Point Beach Nuclear Plant, Unit 1  
Docket 50-266  
License No. DPR-24  
NRC Order EA-03-009 Relaxation Request Supplement 2

### RESPONSE TO REQUEST FOR ADDITIONAL INFORMATION NRC ORDER EA-03-009 RELAXATION REQUEST SUPPLEMENT 2

#### POINT BEACH NUCLEAR PLANT, UNIT 1

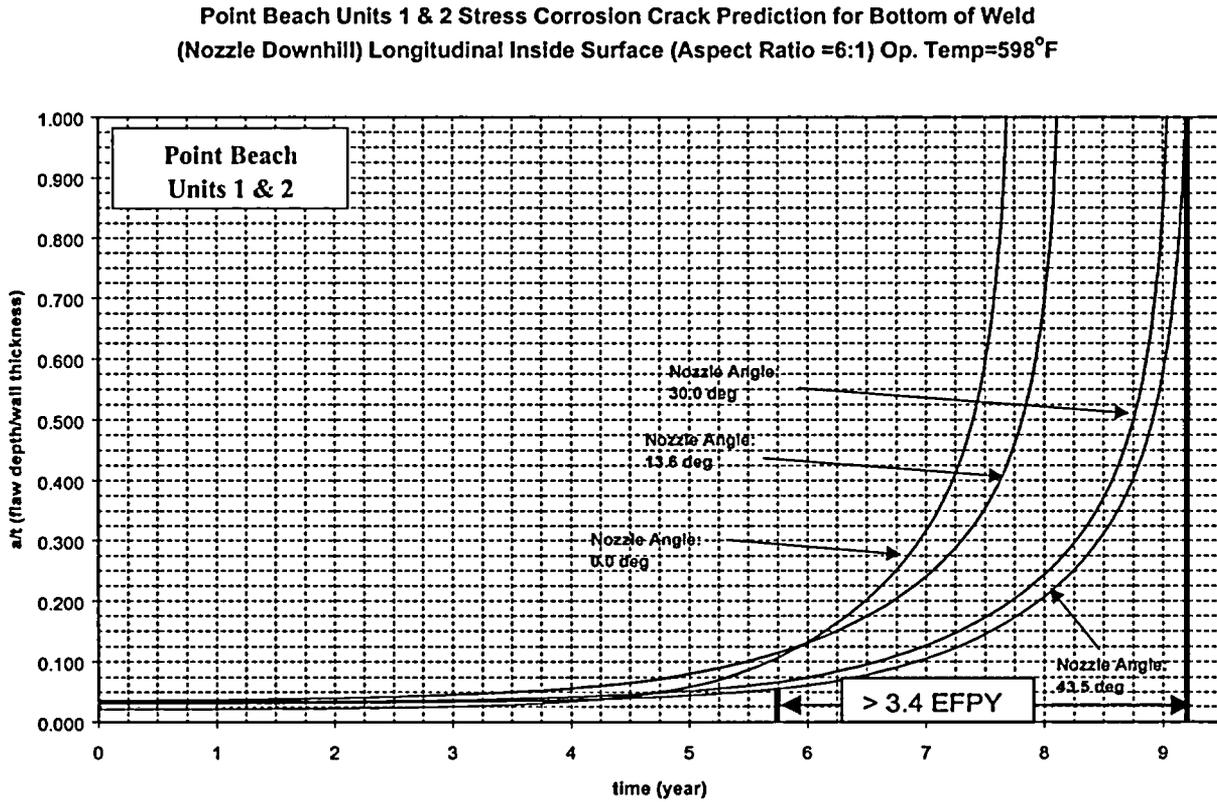
Figure 6-5 of WCAP-14000 is reproduced below. This figure represents a crack growth prediction for axial inside surface flaws near the attachment weld on the downhill side. The 43.5° curve is used. The flaw aspect ratio is 6:1. For an initial a/t value of 0.06, a flaw would require over 3.4 EFPY to reach a through-pressure boundary of 1.0 a/t.

**Figure 6-7**

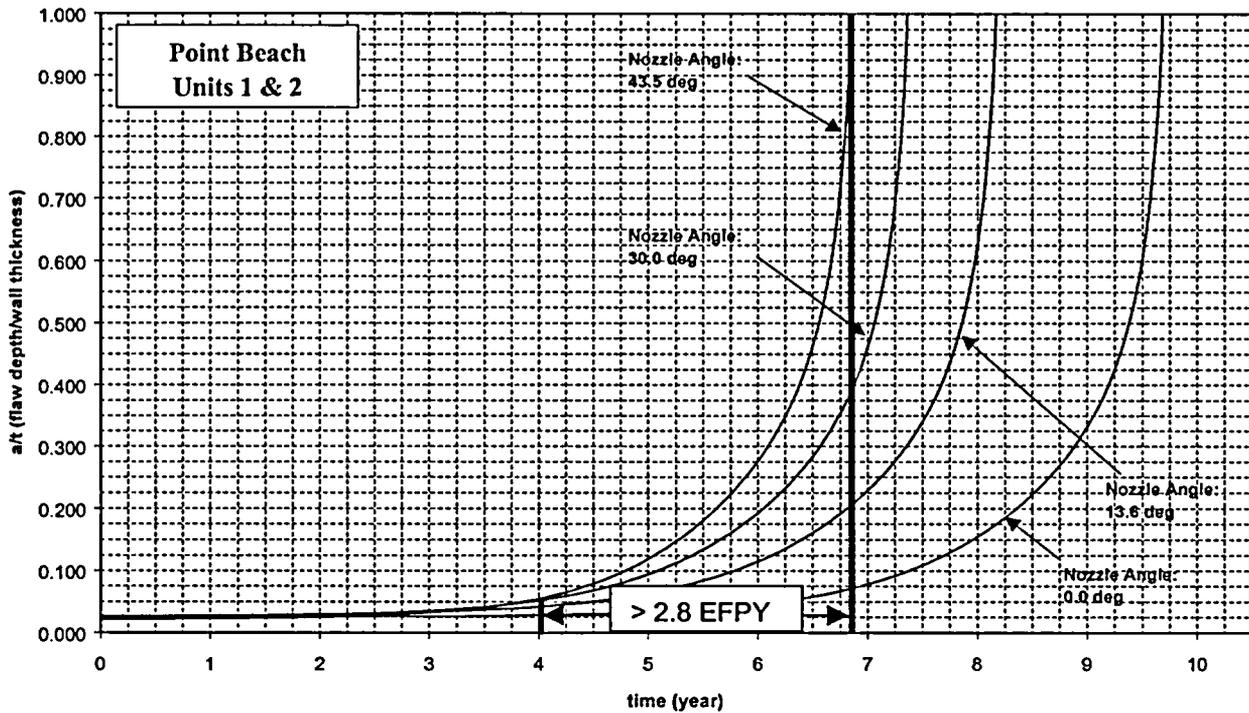
Figure 6-7 of WCAP-14000 is reproduced below. This figure represents a crack growth prediction for axial inside surface flaws above the attachment weld on the downhill side. The 43.5° curve is used. For an initial a/t value of 0.06, a flaw would require over 2.8 EFPY to reach a through-pressure boundary of 1.0 a/t.

PBNP operates on an 18-month cycle and will be replacing the RPV head during the next refueling outage scheduled for fall 2005. Unit 1 operation following the fall 2002 refueling outage (initiation time of the postulated flaw) and the replacement of the RPV head will not exceed 2.8 EFPY. Therefore, a worst-case flaw could not progress through-wall during the next Unit 1 operating cycle.

Figure 6-13

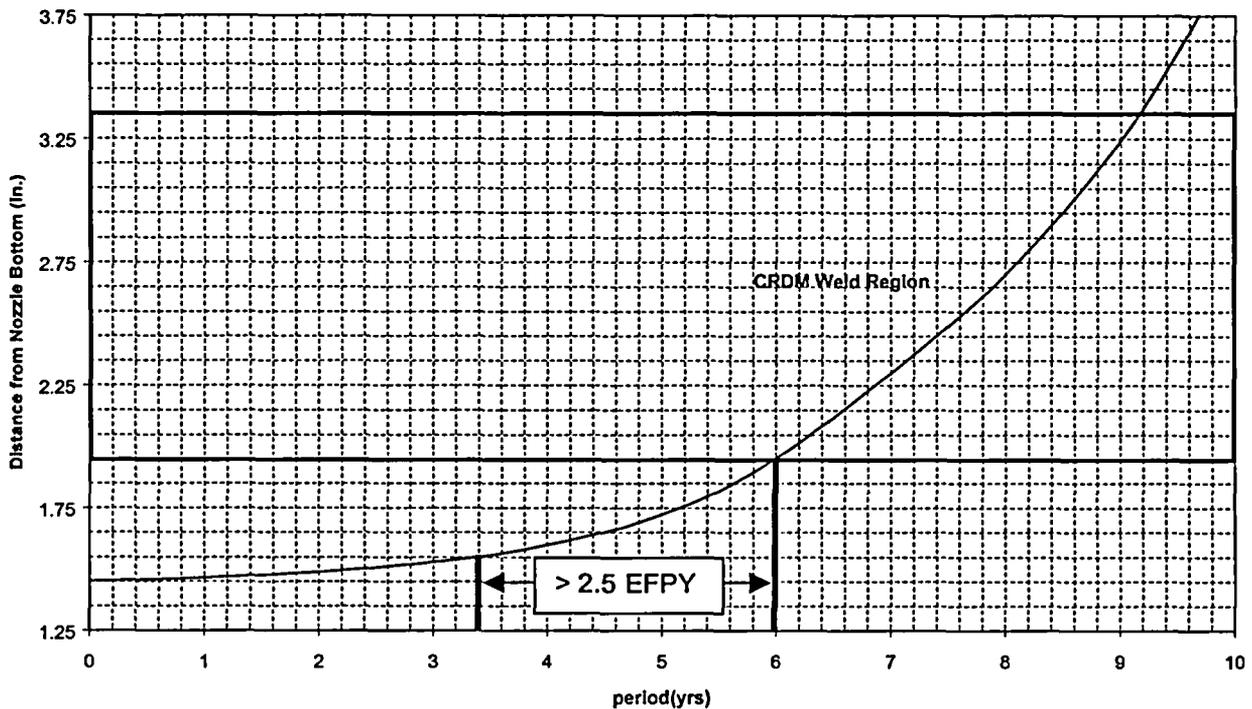
Figure 6-13 of WCAP-14000, shown below, is a crack growth prediction for through-wall axial flaws located in the 30.0° penetration ring. Nozzle 20 is the limiting nozzle for this assessment and is also located in the 30.0° penetration ring. As shown below, the assumed through-wall flaw would take over 2.5 EFY to reach the J-groove weld.

PBNP operates on an 18-month cycle and will be replacing the RPV head during the next refueling outage scheduled for fall 2005. Therefore, a worst-case flaw could not progress sufficiently to reach the J-groove weld during the next Unit 1 operating cycle. Thus, the values used in our calculation are considered appropriate and conservative.
